## VOLKSWAGEN/AUDI ZF5HP19FL/FLA NEUTRALS ON TAKEOFF

## Technical Service Information

Figure 3

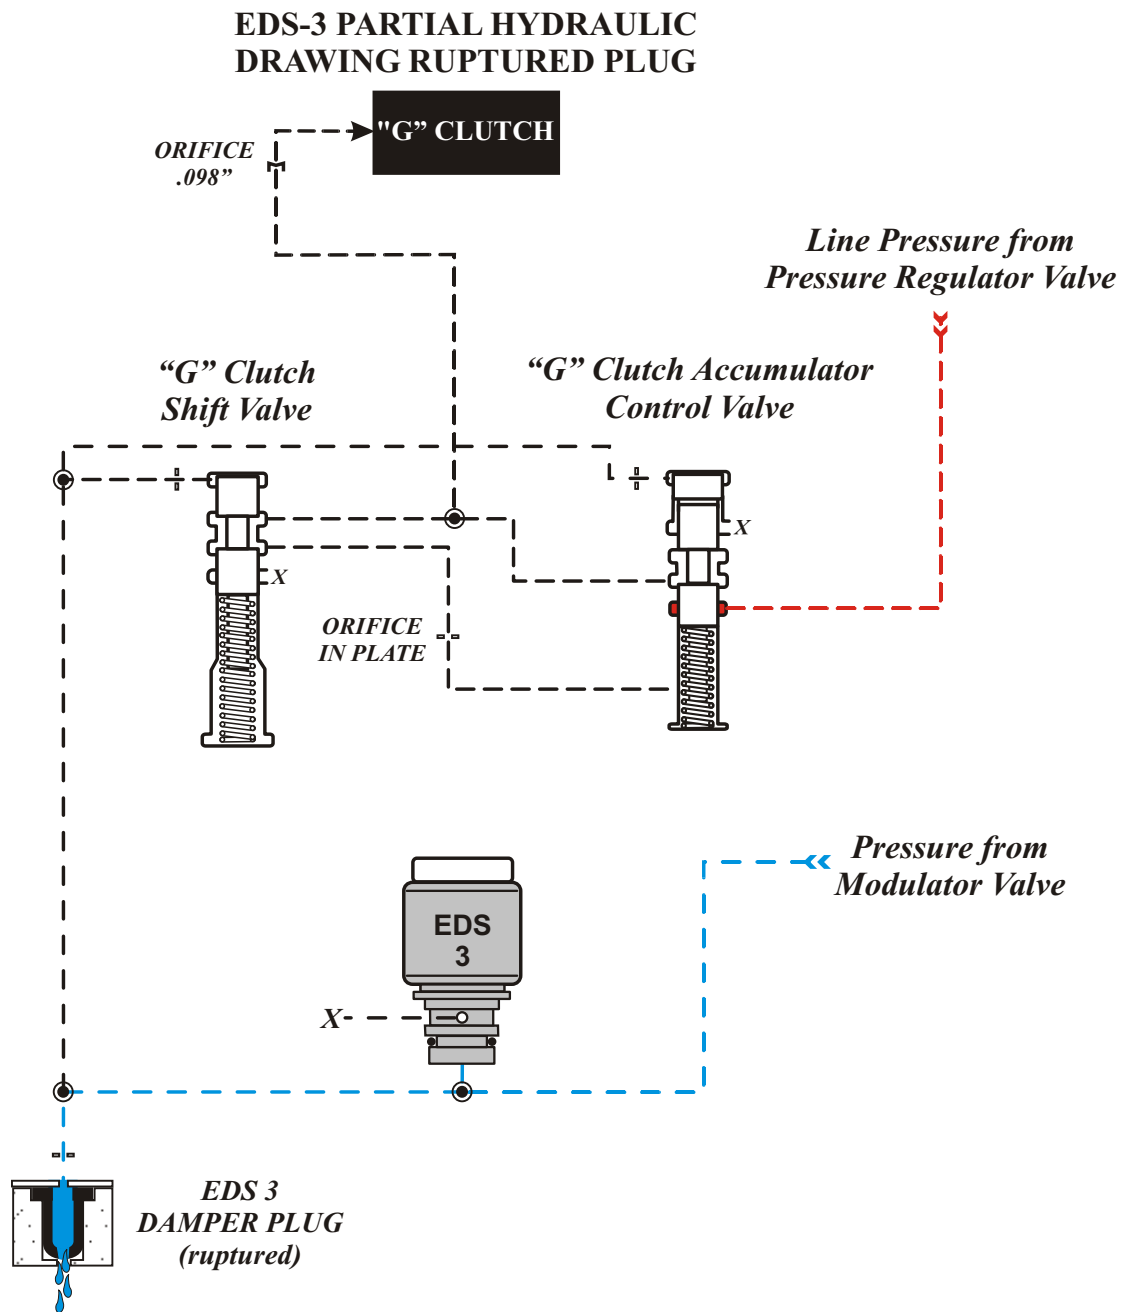
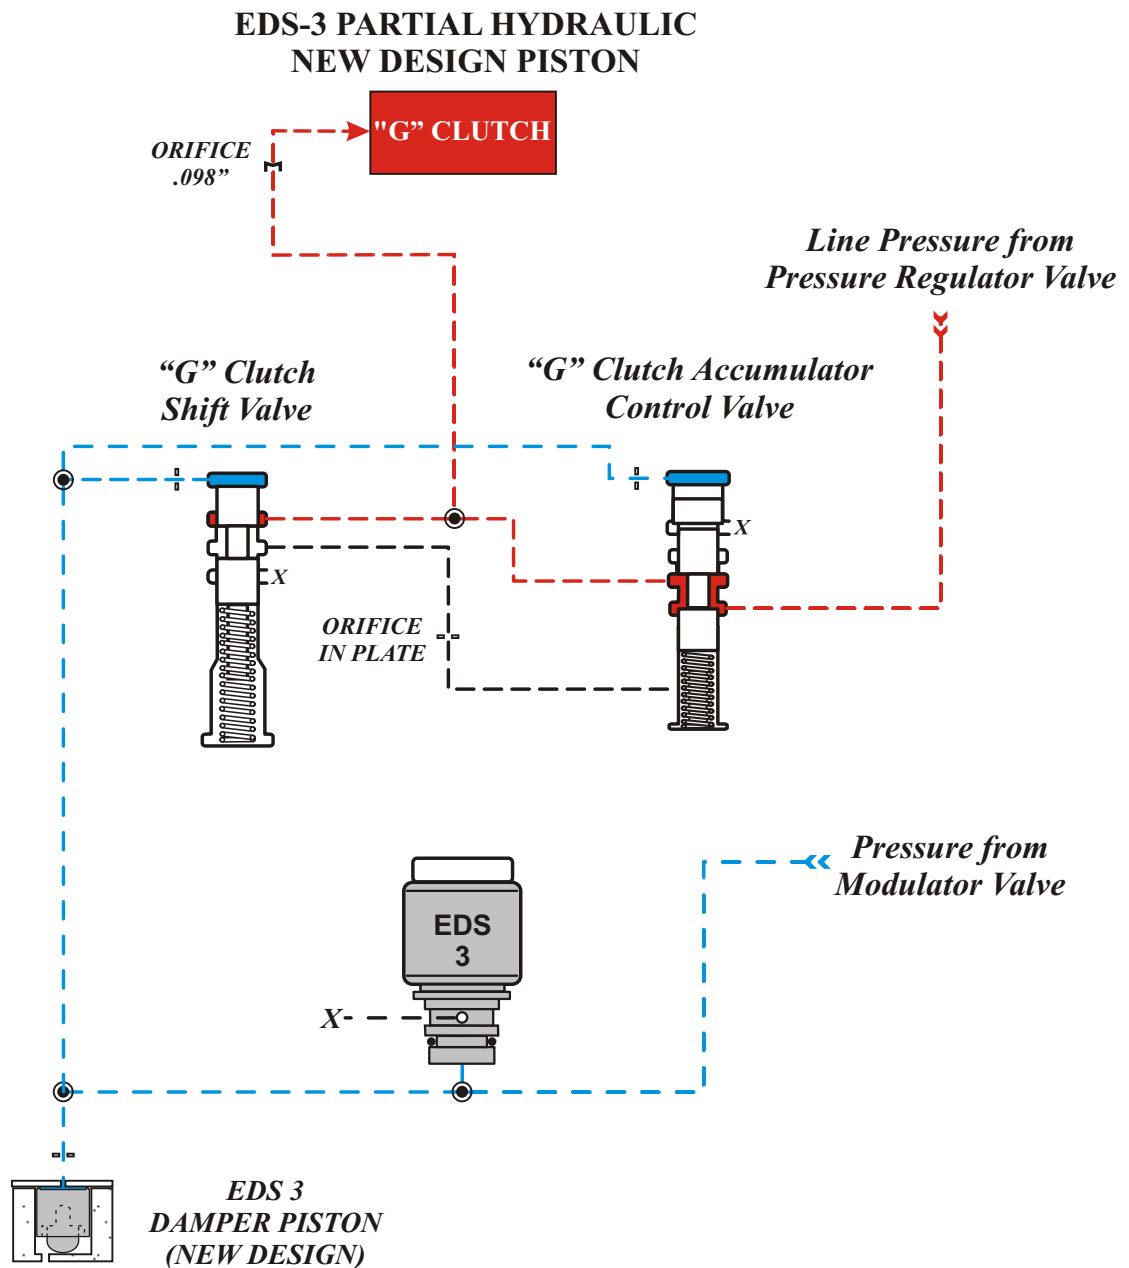
*EDS 3 is used to control the engagement of the "G" clutch. This hydraulic circuit drawing shows oil flow with a ruptured EDS 3 Damper.*

**NOTE:** *With a ruptured EDS 3 Damper Plug, EDS 3 oil pressure exhausts through the hole in the bottom of the damper plug thereby not accumulating and passing to both Shift Valve "G" and Accumulator Control Valve "G".*

*This hydraulic circuit drawing shows oil flow with New Design EDS 3 Damper Piston.*

**NOTE:** *With a new design damper piston installed in the valve body, oil pressure only contacts the face of the plug. Since the hole is eliminated in the new plug, it reduces the possibility of the plug rupturing, and normal oil accumulation is achieved.*

## EARLY CHANNEL PLATE WITH RUBBER PLUGS

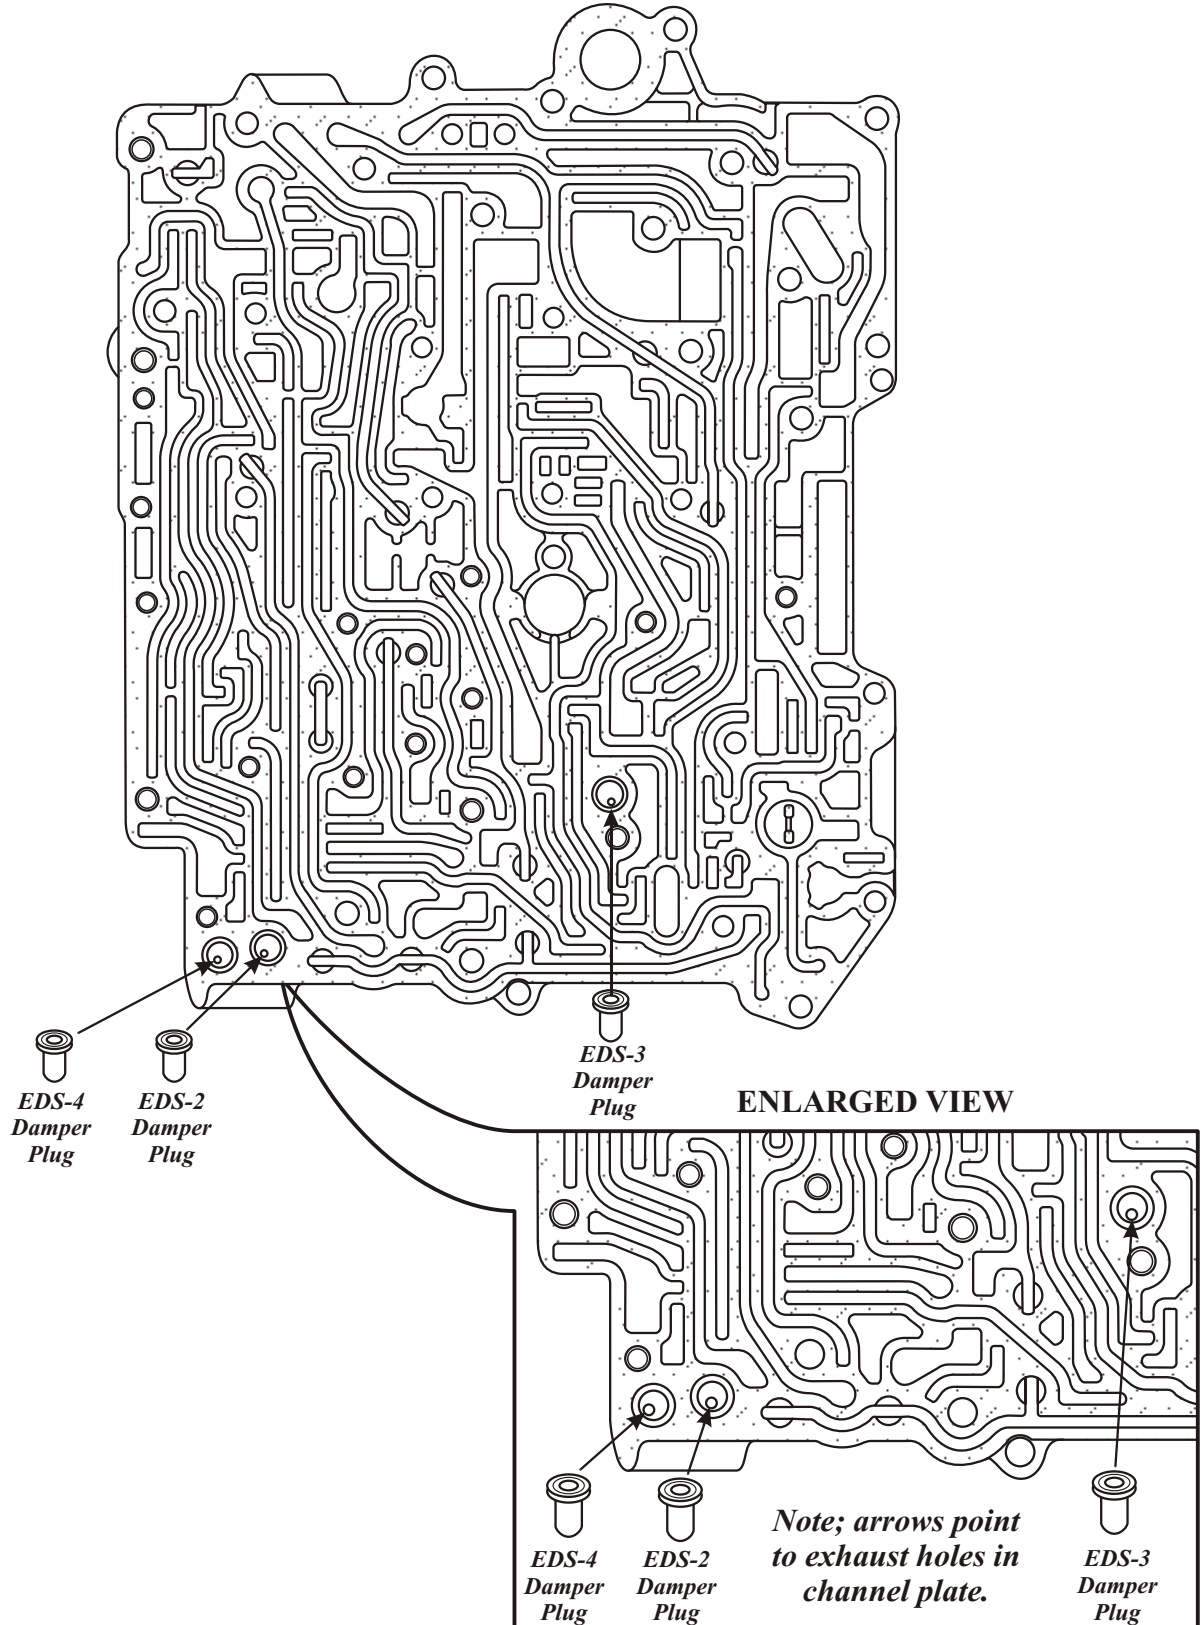
**CORRECTION:** Replace the rubber damper assembly, or use the updated aluminum plugs which requires the updated channel plate and spacer plate. Refer to Figure 2 this picture shows the channel plate with the EDS damper plug locations, and also an enlarged view which shows the early style rubber plugs and focuses on the exhaust holes in the channel plate. These rubber damper plugs were used in ZF5HP19 models through 1999. During model year 2000, ZF introduced an updated damper assembly. Figure 4 shows worm track differences in the later channel plate and also an enlarged view which depicts the later style damper pistons and illustrates the bore size difference in the channel plate for the later damper pistons. Refer to Figure 3. This drawing illustrates the same partial hydraulic circuit in Figure 1, *except*, it shows the new design EDS 3 accumulator piston. Notice the top of the accumulator piston, there is no orifice like in the previous plug, instead the surface is solid and in the bottom of the plug is a rubber insert that provides the cushion, or accumulation. The solid top obviously prevents rupturing and these new pistons eliminate the problem.

Figure 4

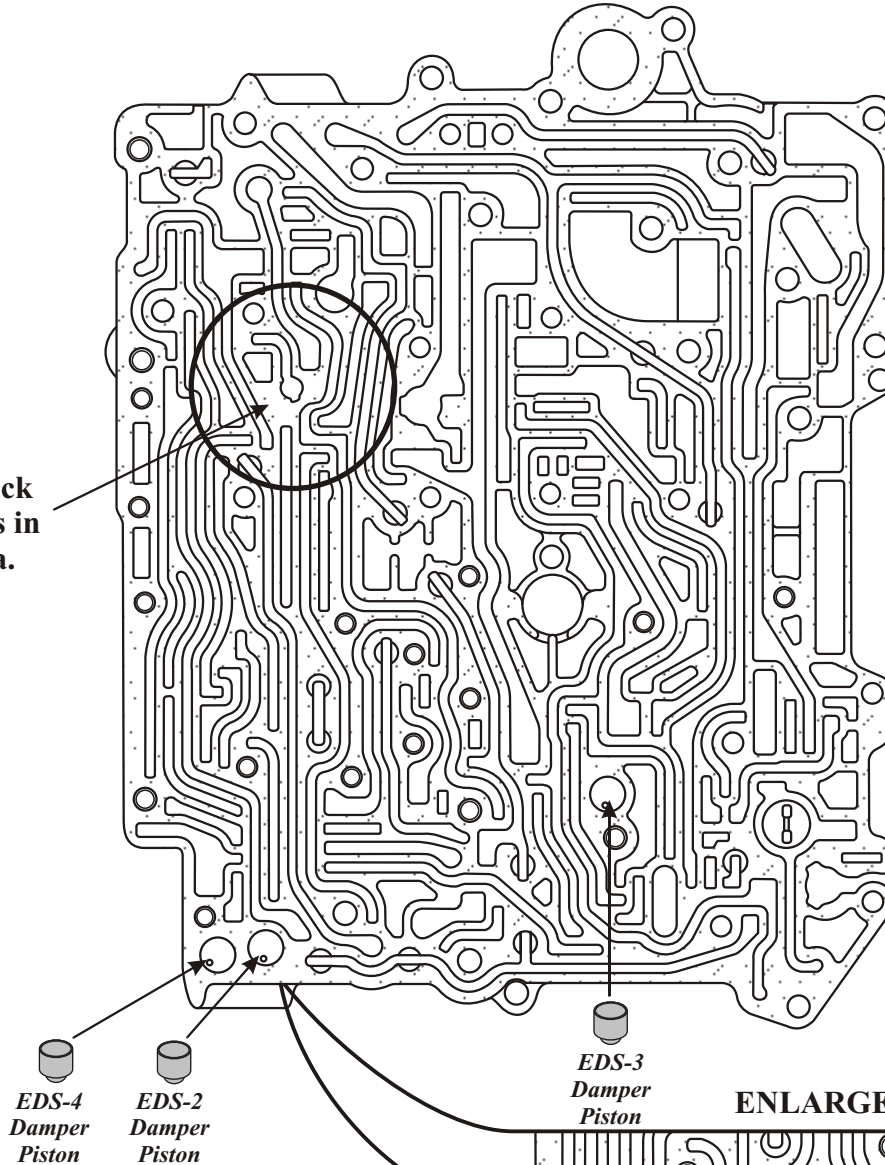
Refer to Figure 4. The text in the enlarged view states the accumulator bores in the channel plate are larger in diameter than the early plate. The bores are larger in diameter to accommodate the updated pistons. The diameter of the accumulator plug bore in the early channel plate is approximately .315 inches and houses the rubber damper plug. The outside diameter of the accumulator piston bore in the later channel plate is approximately .471 inches in diameter for the updated piston. Figure 5 shows the early valve body separator plate, and Figure 6 shows the later separator plate. Note the differences in hole size and configuration between the two plates. ***They are not interchangeable.*** Therefore, if you have a rubber damper that is ruptured, you will have to use a new rubber damper. If you want to use the later style piston to prevent a future incident, you will need to purchase a new channel plate, separator plate and pistons from a ***ZF-AUTHORIZED*** distributor. Most overhaul kits will come with both the rubber plugs and the newer pistons so if you have an overhaul kit you will only need to purchase the new style separator and channel plate. ***Note:*** There are two different versions of the separator plate and channel plate combinations, the first version is the type that has a Pulse Generator, which supplies Turbine shaft speed to the TCM, and is bolted to the middle of the channel plate. The second version is the type that uses a Hall effect turbine speed sensor, which is bolted the case. These 2 different channel plates are not interchangeable. Refer to the chart below for the correct part numbers for the version needed.

**Note:**  
Worm track  
differences in  
this area.

*Note; accumulator bores  
for the pistons are  
larger in diameter  
than early plate*

Figure 6

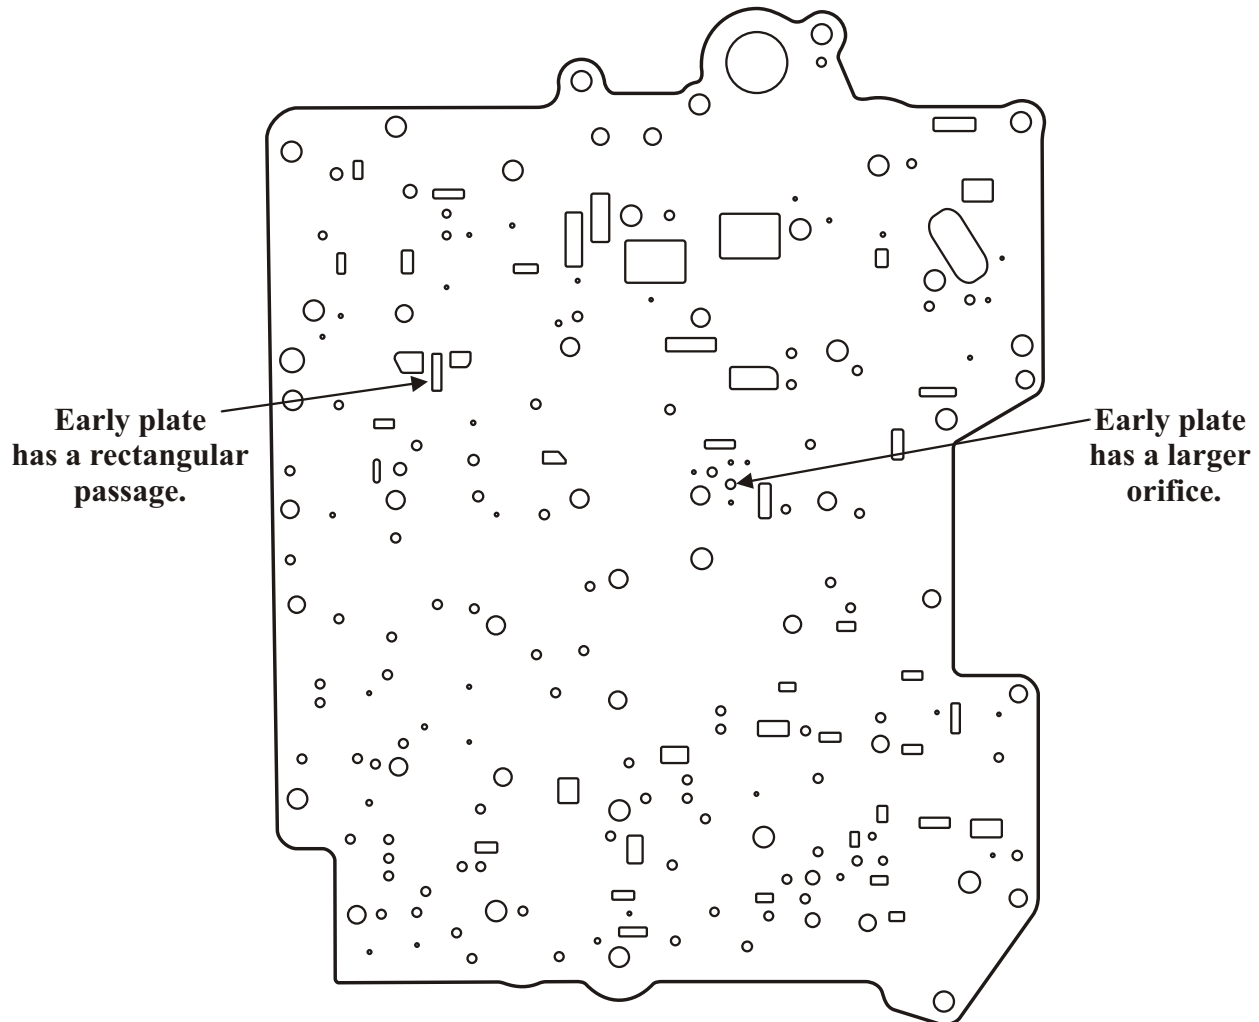
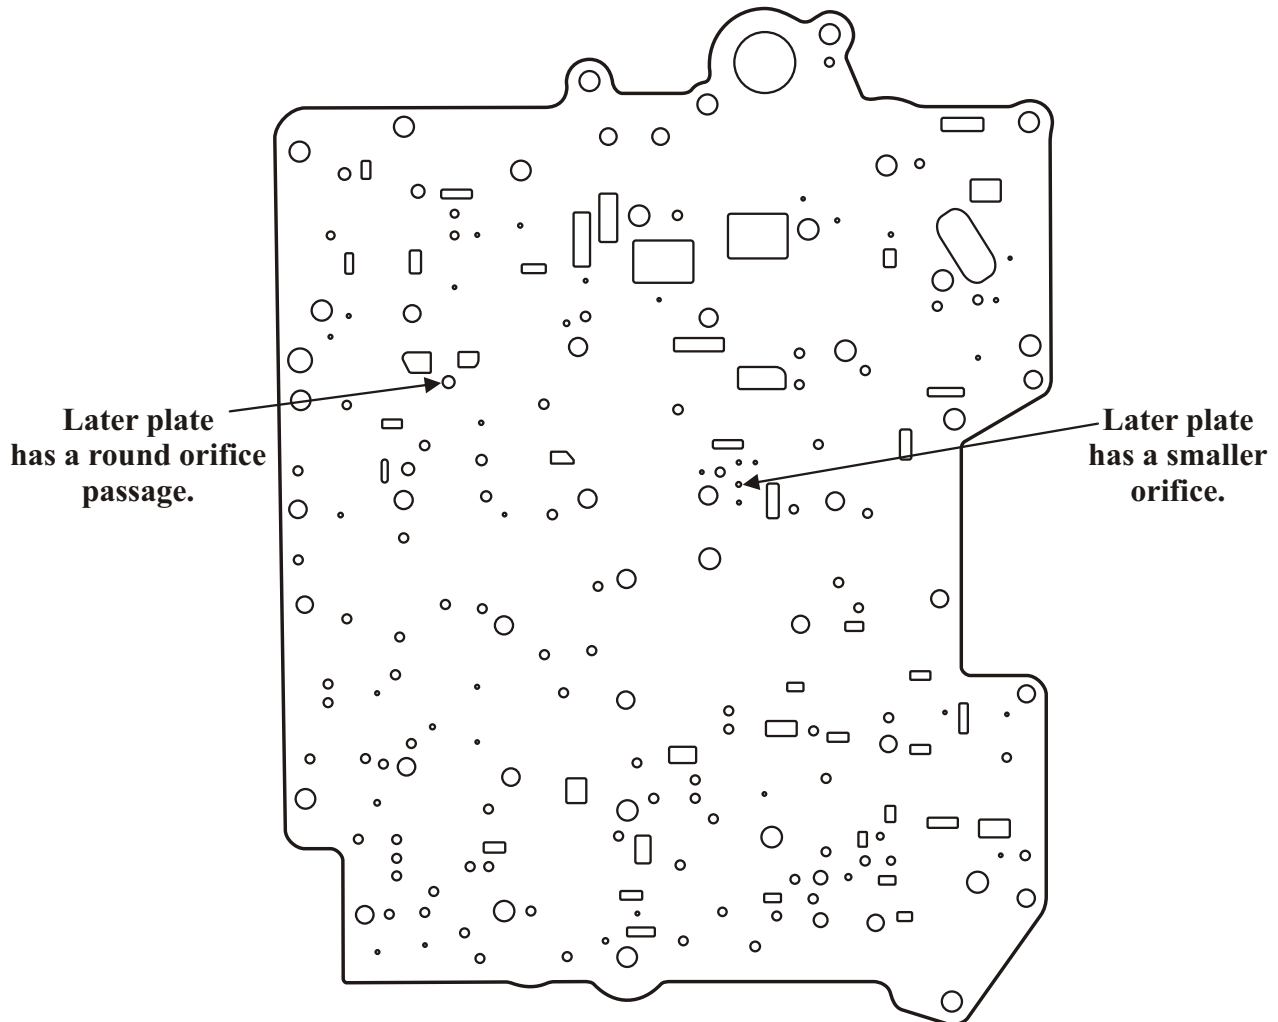
**NOTE:  
SEPARATOR PLATE  
DIFFERENCES**

**NOTE:  
SEPARATOR PLATE  
DIFFERENCES**

SERVICE INFORMATION:	ZF PART NUMBER	ZF PART NUMBER
	FOR PULSE GENERATOR TSS	HALL EFFECT TSS
SEPARATOR PLATE.....	1060-327-109.....	1060-327-127
CHANNEL PLATE.....	1060-327-140.....	1060-327-141
PISTONS (3) REQUIRED.....	1068-227-039.....	1068-227-039
